# Edinburgh Airport Airspace Change Programme 2022

Stage 2 Develop and Assess

Engagement

<b>ACP reference</b>	<b>ACP-2019-32</b>
<b>Version</b>	Final Redacted
<b>Date</b>	25/07/22
<b>Purpose</b>	CAP1616 Stage 2 Gateway Submission to CAA
<b>Classification</b>	Confidential
<b>Author</b>	Edinburgh Airport Limited

# Draft swathe runway 24 to GRICE

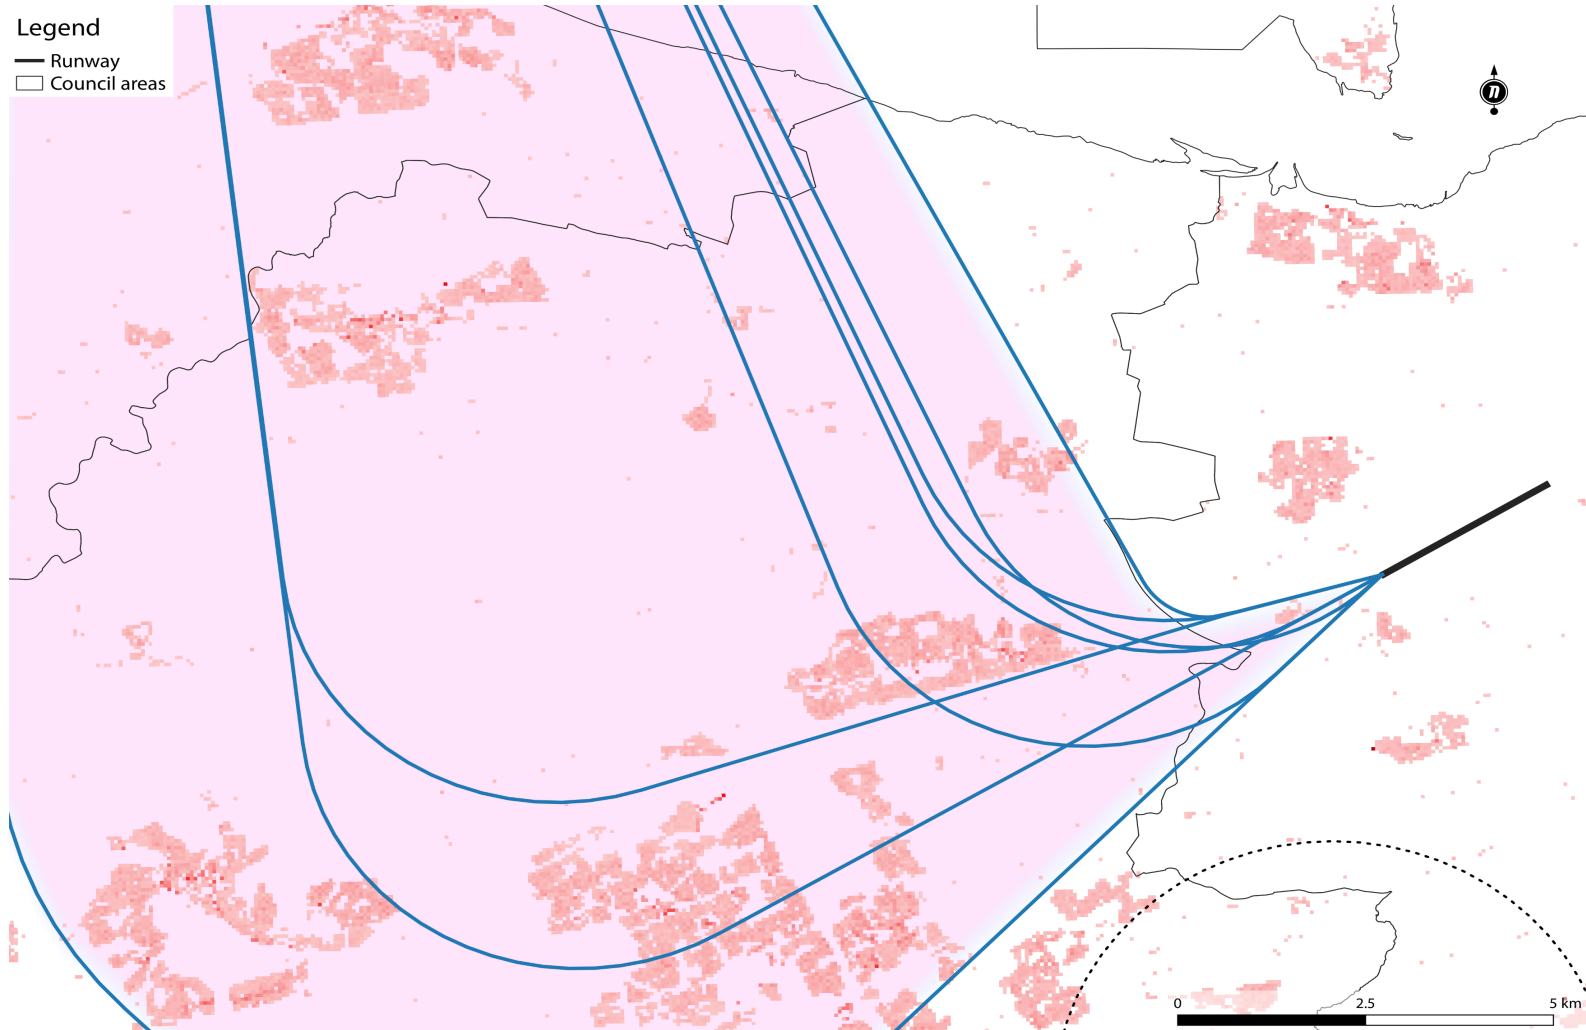
Planning consultant for Winchburgh. You showed a slide for Rwy24 to GRICE. I've been involved for a while, and Winchburgh is going through strategic expansion to a population of 11000 and Broxburn

The answer is that we would look at our available maps and look at projected residential areas 10 years hence and this ACP has to be fit for purpose for 10 years taking into account these future plans. We would try to get the best route taking into account future populations. This is important that the growth areas are factored in.

# Responses related to airspace around / near Edinburgh

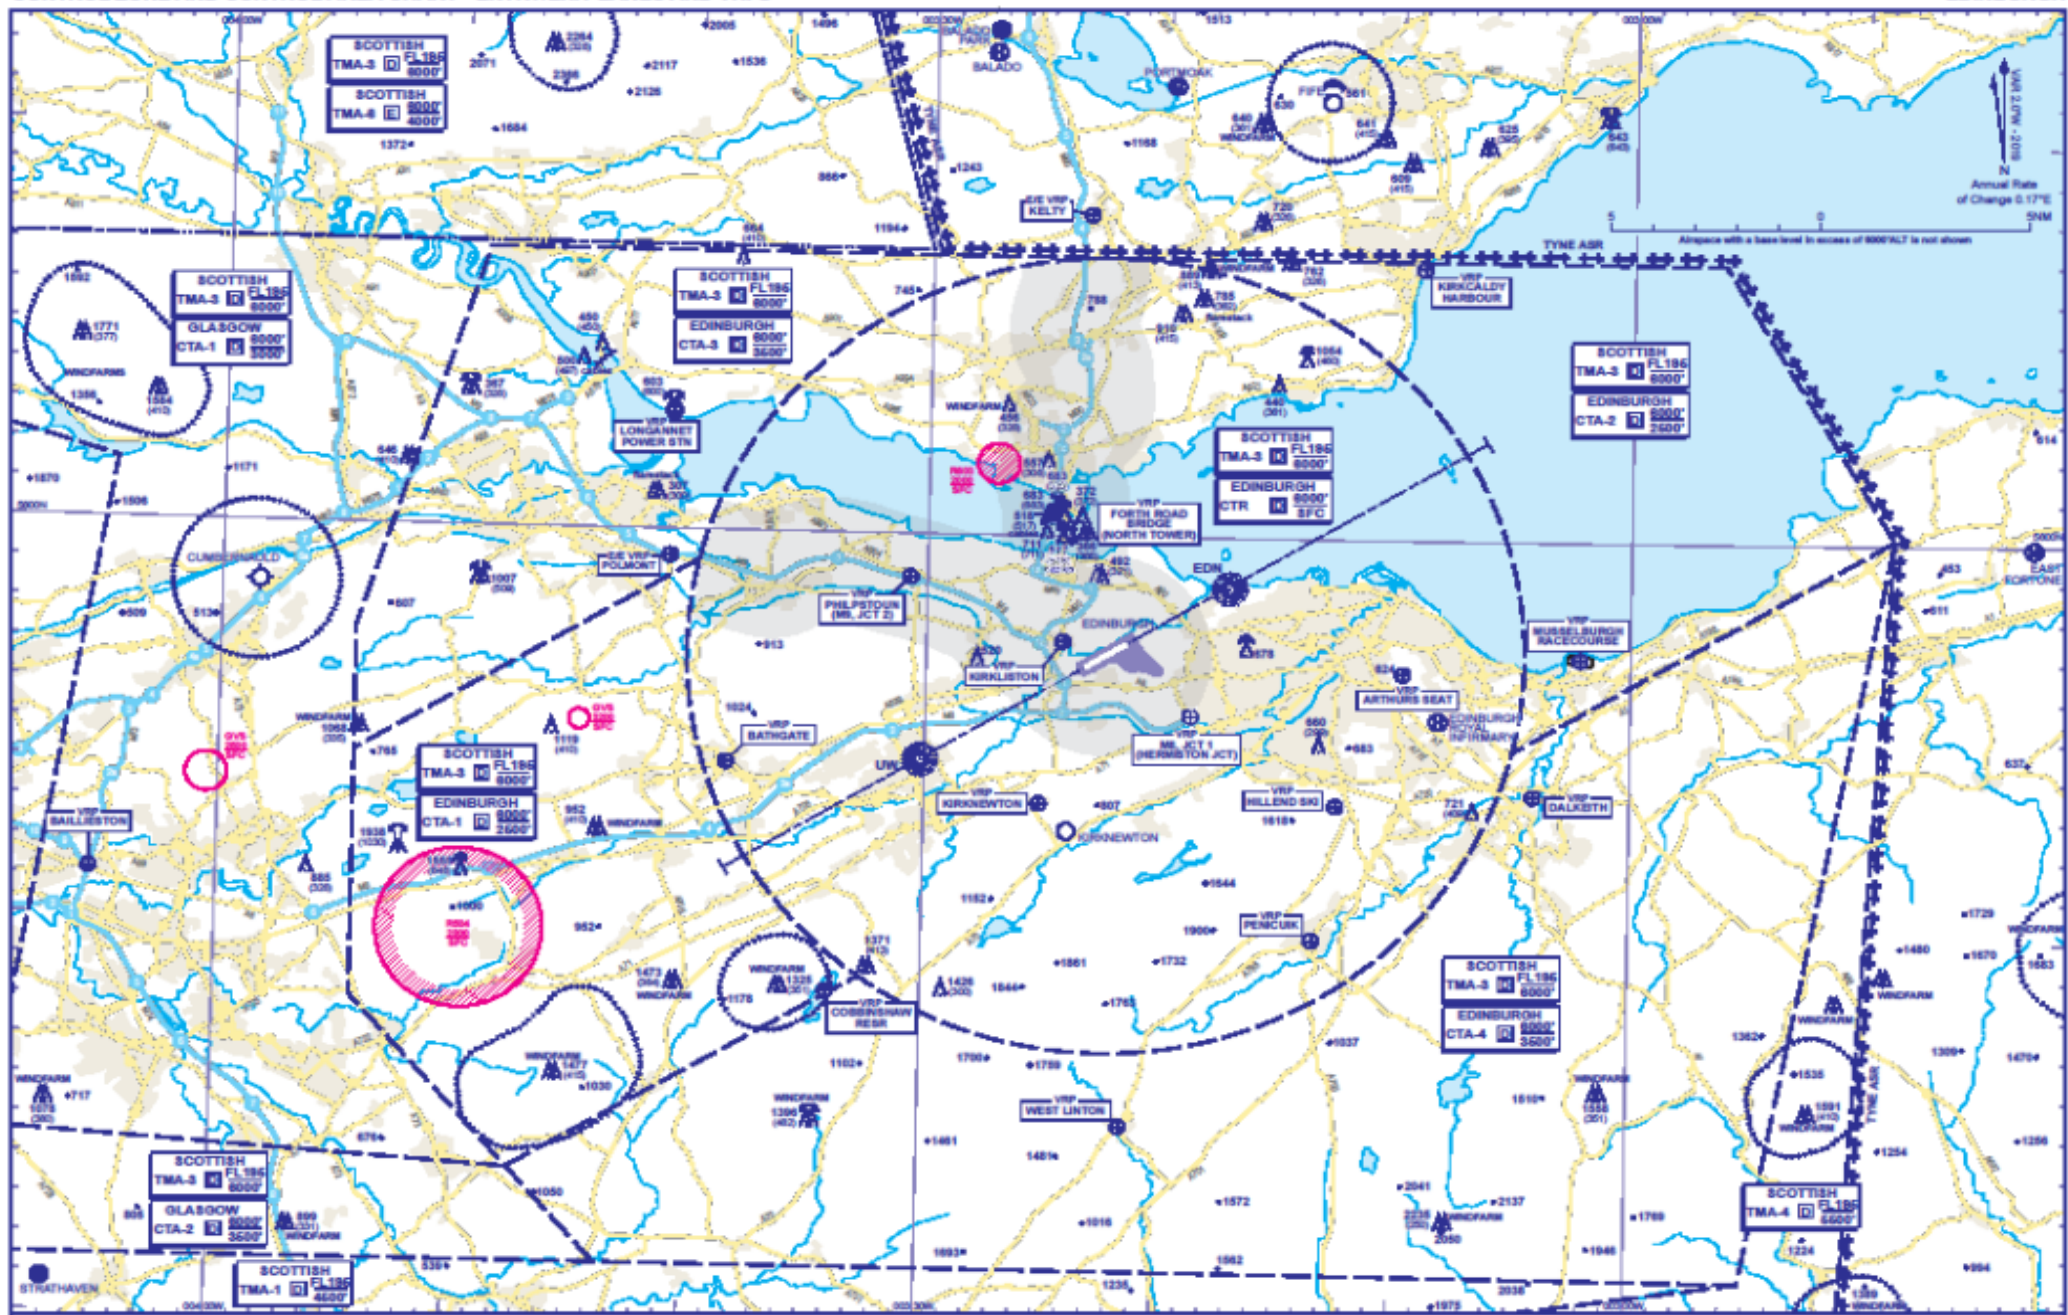
The responses on Edinburgh controlled airspace have requested that the Edinburgh CTA base levels to be raised, particularly Edinburgh CTAs 2, 3 & 4. The focus being on removing airspace associated with Runway 12/30.

**Summary** – The responses on airspace between Edinburgh and Glasgow highlight the following:

- Below Glasgow CTA 1 is the only North/South corridor for GA traffic to transit through without having to fly over the sea.
- Gap between Edinburgh and Glasgow is narrow and has a low base level.
- Access to Cumbernauld airport made difficult due to the proximity to Edinburgh airspace and low base level.
- Transiting North/South between Edinburgh and Glasgow made difficult for gliders and other GA aircraft due to areas of high terrain combined with the low base level.
